Re: Tiger Bay Cogeneration Facility  
Draft Title V Permit No.: 1050023-002-AV  
**1050223**

Florida Power Corporation (FPC) is providing comments related to the draft Title V permit dated October 27, 1998. Our comments are directed at specific conditions for the facility and emissions units. The comments are presented below in the same order as the conditions appear in the initial draft permit. FPC has filed a Request for Extension of Time until February 1, 1999. In this regard, if we are unable to resolve each of the issues described below before this time, FPC intends to file an additional Request for Extension. Accordingly, at your earliest convenience after reviewing this letter, please contact me at (727) 826-4258 to discuss.

Re: 7FA Gas Turbine Soft Start Sequence

7F/FA MSCC W/IBH

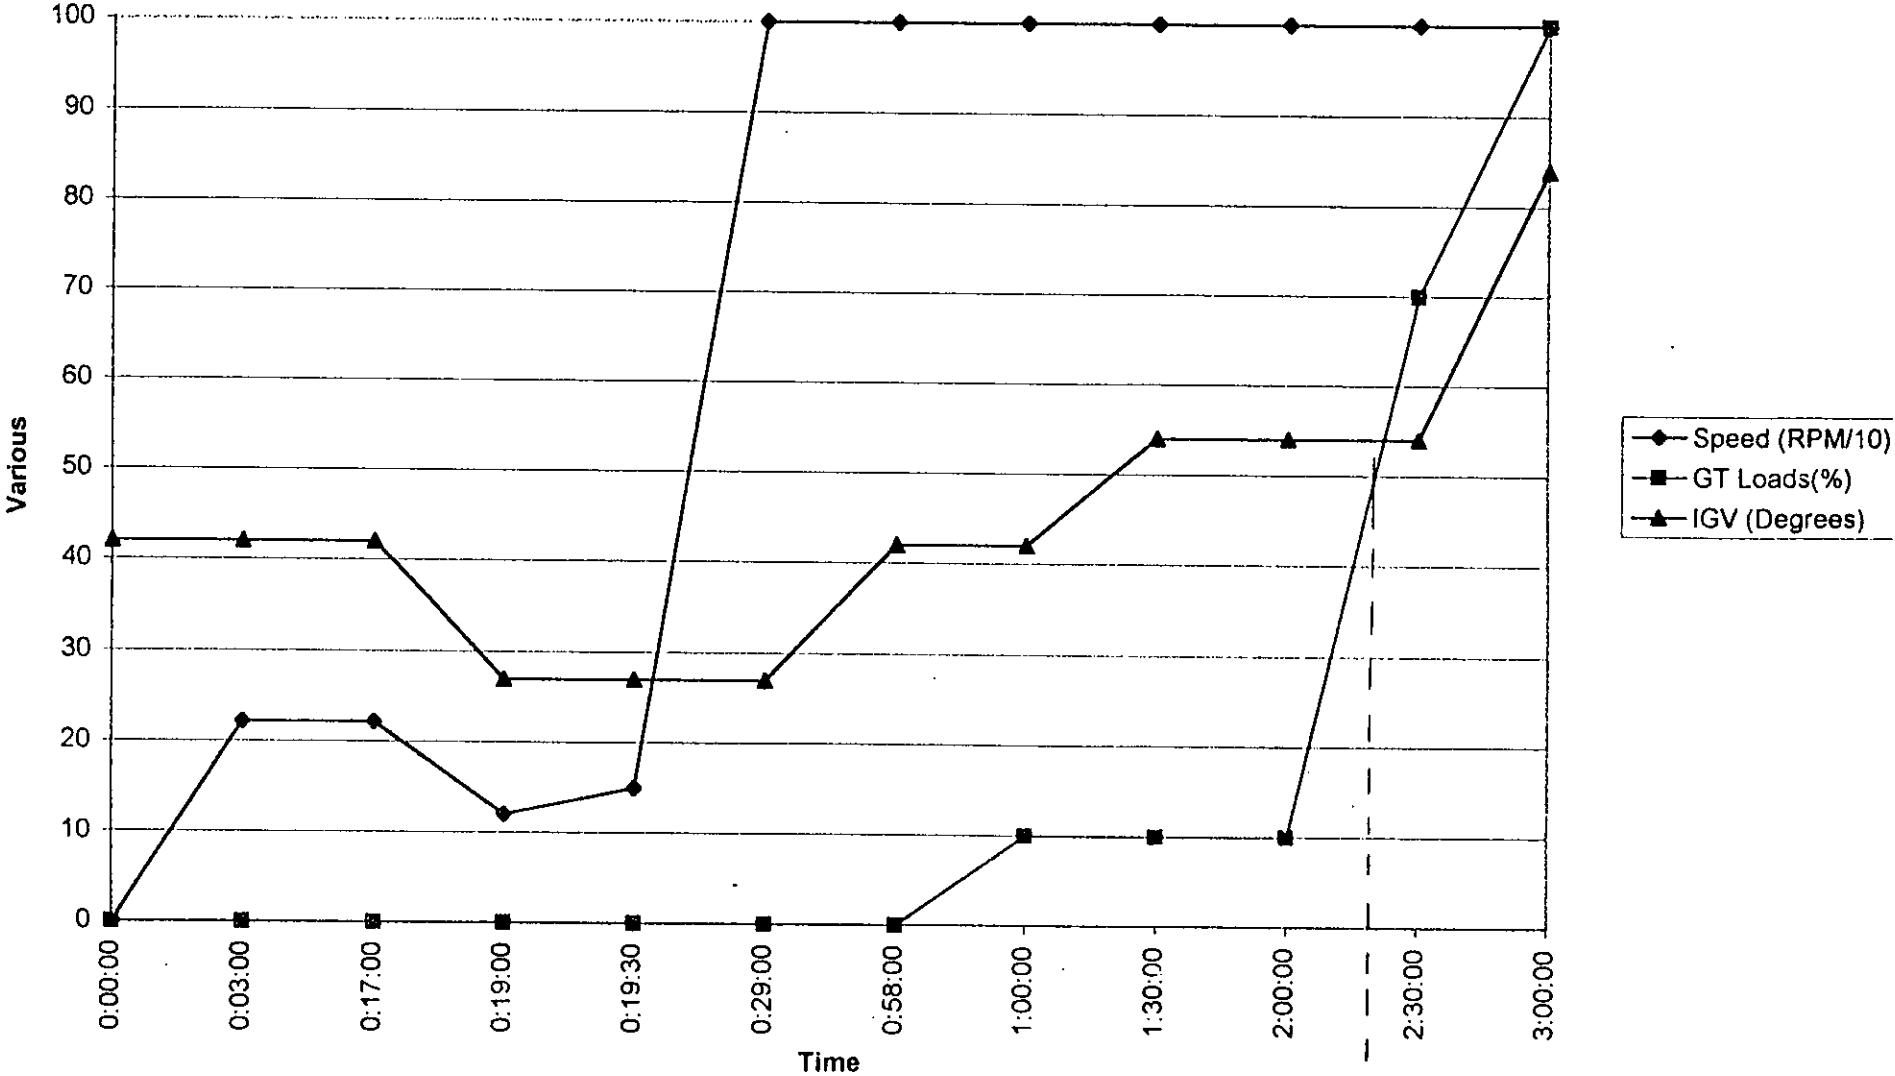
Generally in 27-30 ppm during startup. Provide Best Operational Practice from GE.  
Page 11. Condition A.35. In accordance with the attached start-up curve, FPC requests that this unit be specifically authorized to have excess emissions for 3 hours (rather than 2 hours) in any 24-hour period, unless specifically authorized by the Department for longer duration. Also, the pertinent excess emission provisions of 40 CFR Part 60 should be included in this section of the permit, i.e., §§ 60.8(c), 60.11(c), and 60.43c(d). check w/ Bruce would this have to be proved by Mike Hurley's group

Of note is the long period at which the gas turbine operates below the steady state pre-mix mode (just over 2 hours from initial start up command). At loads below steady state pre-mix the combustion system is not capable of achieving 25 ppmvd NOx levels. Shortening of the cycle to get the turbine into steady state pre-mix sooner would offset the benefit of allowing the slower warm-up of the turbine rotor and may result in pre-mature failure of turbine components.

Per your request attached please find a graph showing the start up sequence for the 7FA at Florida Power's Tiger Bay Facility. As we discussed the attached sequence occurs automatically after any gas turbine shutdown of 50 hours or more duration. General Electric has added this revised start up sequence (titled "Soft Start") to the gas turbine controls as a protective measure to minimize potentially damaging thermal stresses in the turbine rotor during a cold startup.
